# **TEDS EXCEPTION REQUEST**

**Teller Arms, Block 7  
2410 North Avenue  
HASTINGS**

Re: Design Exception #DE #34-06 – 2410 North Avenue Driveway Spacing and Throat Length (Teller Arms)

## DESIGN EXCEPTION #34-06

**PROPOSED LAYOUT**

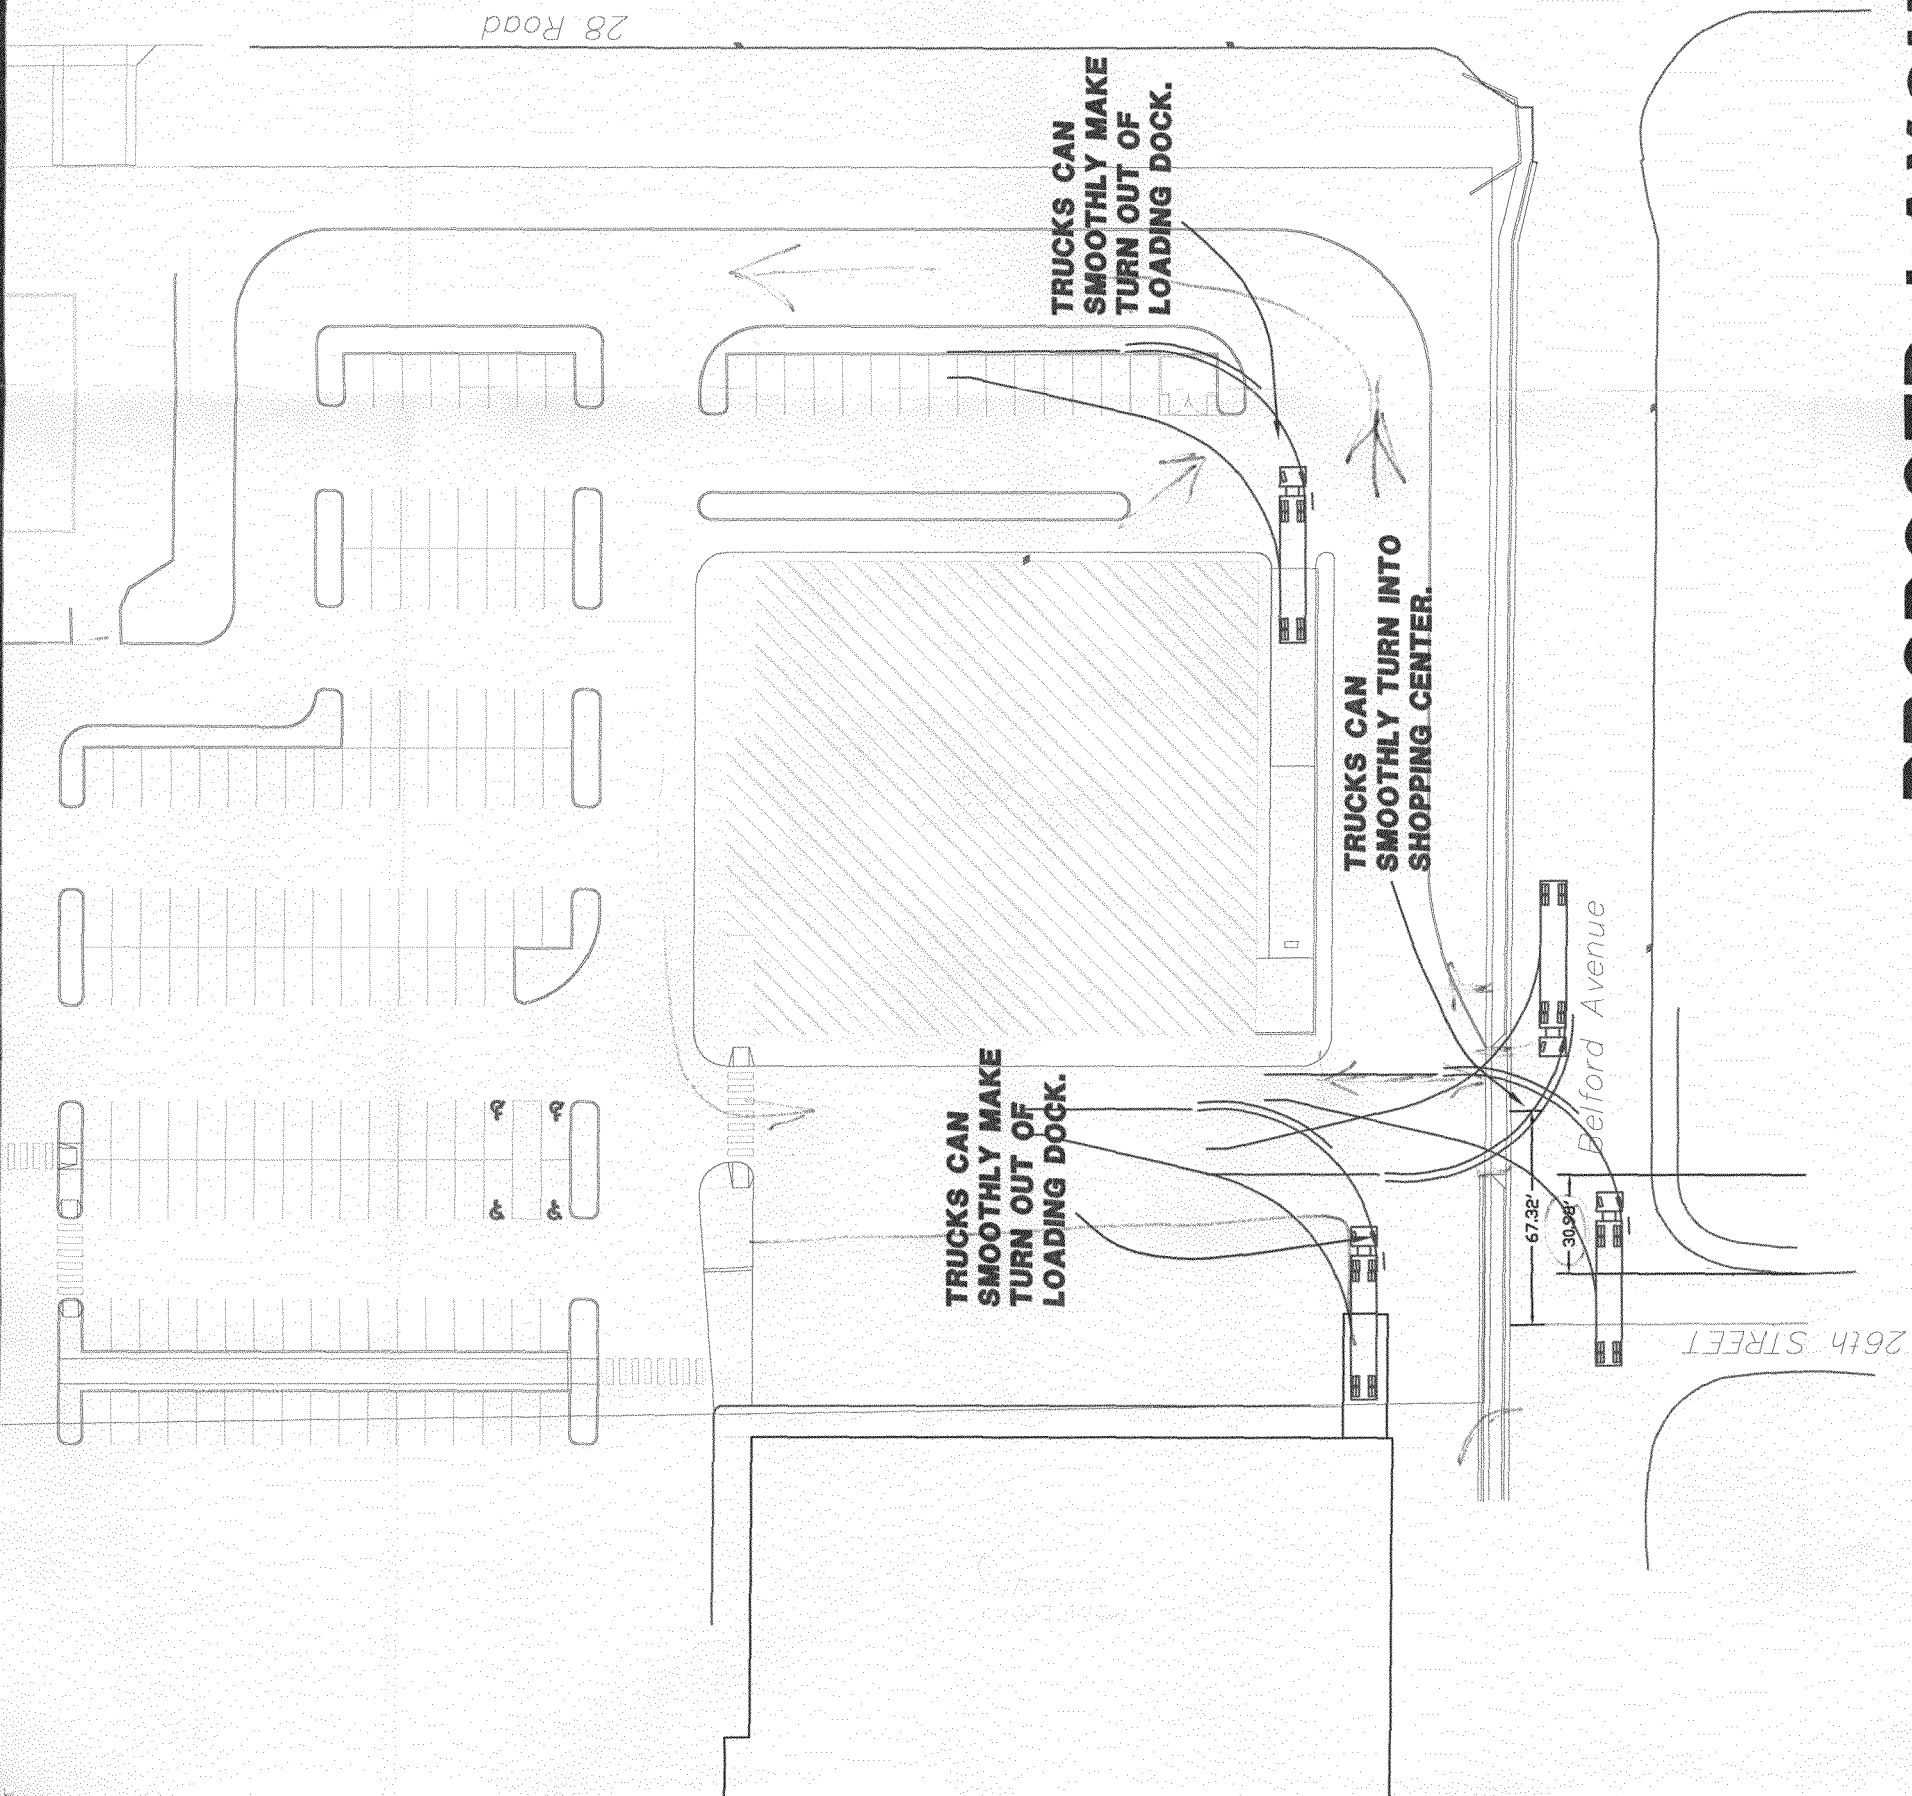
TRUCK TRAFFIC HAS ROOM TO MANEUVER,  
PLENTY OF AVAILABLE SPACE TO  
STRAIGHTEN OUT IN FRONT OF LOADING  
DOCKS AND BACK INTO THEM.

TRUCKS TURNING INTO SHOPPING CENTER  
FROM BELFORD ARE ABLE TO TURN  
DIRECTLY INTO NORTH/SOUTH DRIVE.

15 PARKING SPACES AND ROOM FOR  
DUMPSTER ON EAST SIDE OF BUILDING,  
KEEPS DUMPSTER AND TRASH TRUCKS  
AWAY FROM CUSTOMER PARKING.

TRUCKS FROM BELFORD AVE. MAY HAVE TO  
MANEUVER TO GET EASTBOUND ONTO DRIVE  
THAT IS PARALLEL TO BELFORD AVE.  
HOWEVER, THIS SHOULD BE FEASIBLE.

The TEDS Committee agreed that the minimum throat length requirement could be reduced to accommodate your plans for access onto Belford, but did not agree to vary the 50' offset requirement between 26<sup>th</sup> Street and the access point to the development measured from edge of access to edge of access.

**ALTERNATE A**

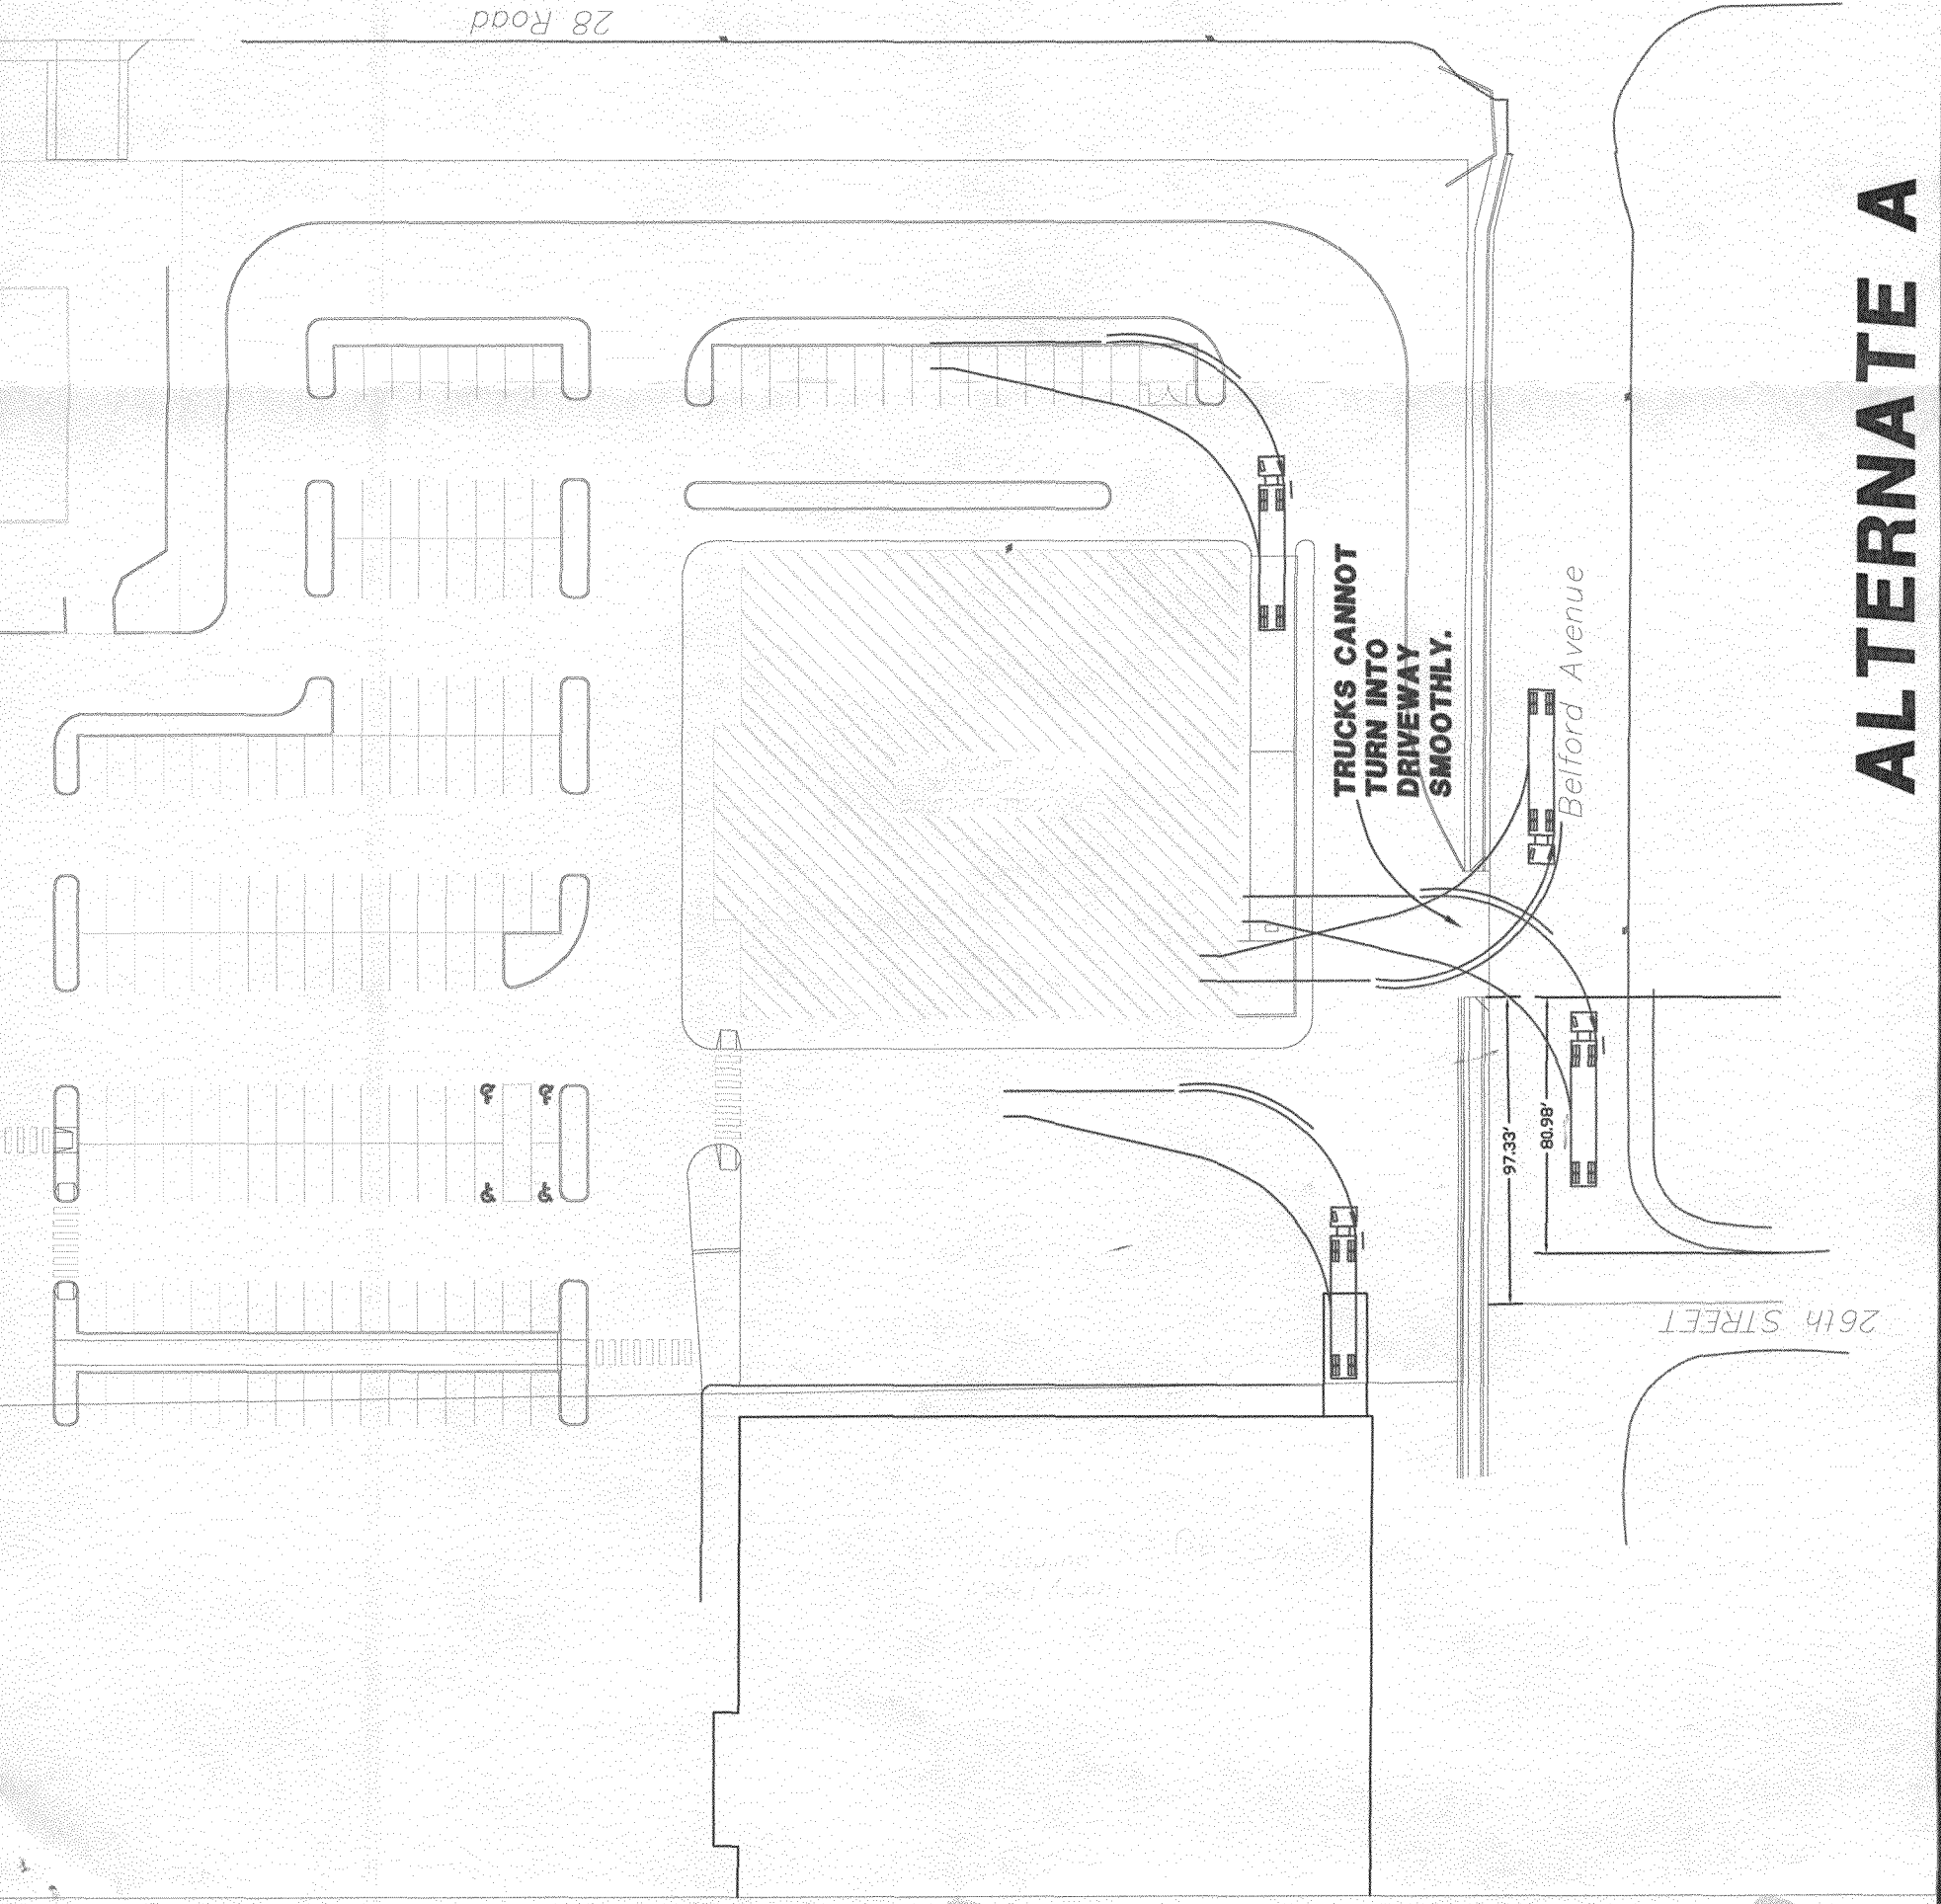
MEETS TEDS STANDARDS.

TRUCKS CANNOT EASILY USE THIS ENTRANCE. THERE IS NO NORTH/SOUTH DRIVE TO TURN INTO AND TRUCKS WILL HAVE TO TURN INTO A DRIVE THAT IS PARALLEL TO BELFORD AVE. THIS WILL REQUIRE BACKING AND MANEUVERING IN MANY CASES.

IF IT IS AWKWARD FOR TRUCKS TO USE THE ENTRANCE ADJACENT TO THE LOADING DOCKS, THEN THEY WILL COME INTO THE SHOPPING CENTER OFF OF NORTH AVE.

**ALTERNATE B**

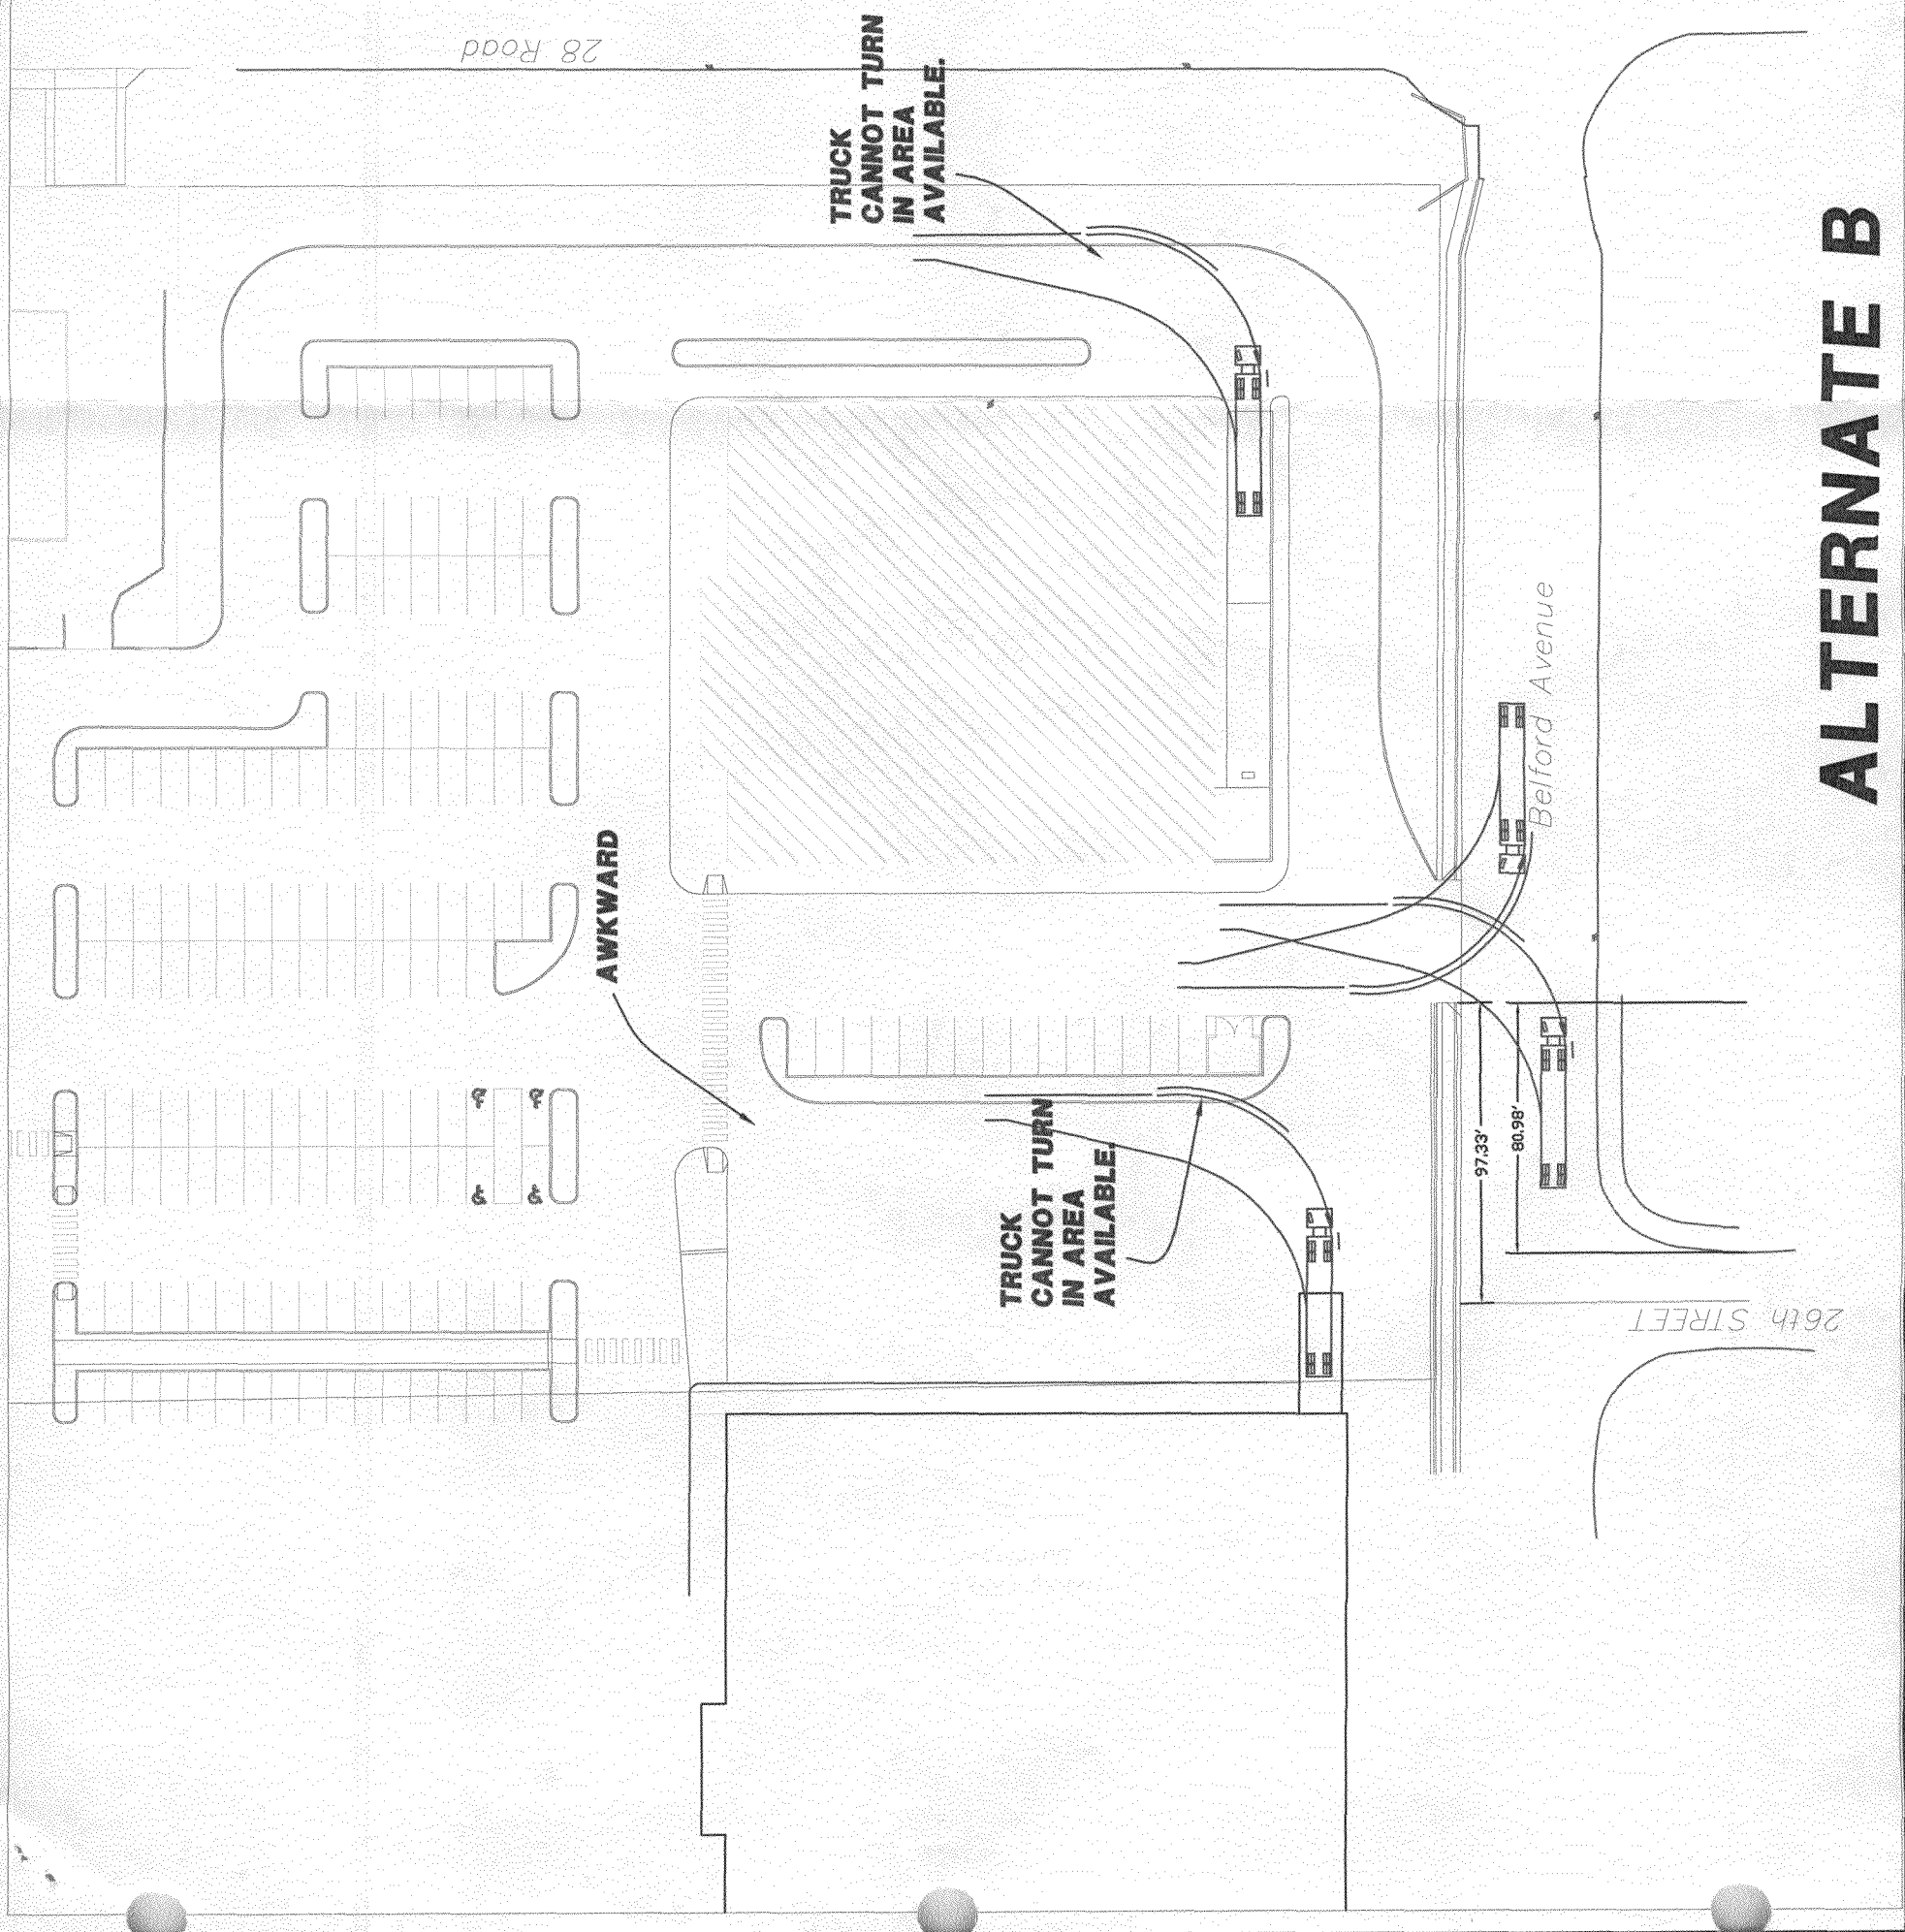
MEETS TEDS STANDARDS. TRUCKS HAVE A NORTH/SOUTH DRIVE TO TURN INTO.

PEDESITRIAL ACCESS FROM NORTH IS MORE COMPLICATED AND CORSESSES MORE DRIVEWAY.

TRUCKS WILL ONLY HAVE EASY ACCES TO NORTH/SOUTH DRIVE.

TRUCKS WILL NOT BE ABLE TO STRAIGHTEN OUT AND BACK EASILY INTO HASTINGS LOADING DOCK. THERE DOESN'T SEEM TO BE ANY LOGICAL WAY FOR A TRUCK TO GET INTO THE HASTINGS LOADING DOCK.

THE SPACE IN FRONT OF THE HOBBY LOBBY LOADING DOCK IS MORE RESTRICTED. THERE IS AN AWKWARD TURN/ENTRANCE AT THE NORTHEAST OF THE HOBBY LOBBY BUILDING, UNLESS THE PARKING AND DUMPSTER AREA IS ELIMINATED.

THIS LAYOUT SEEMS AWKWARD FOR TRUCKS COMING FROM BELFORD AVE.
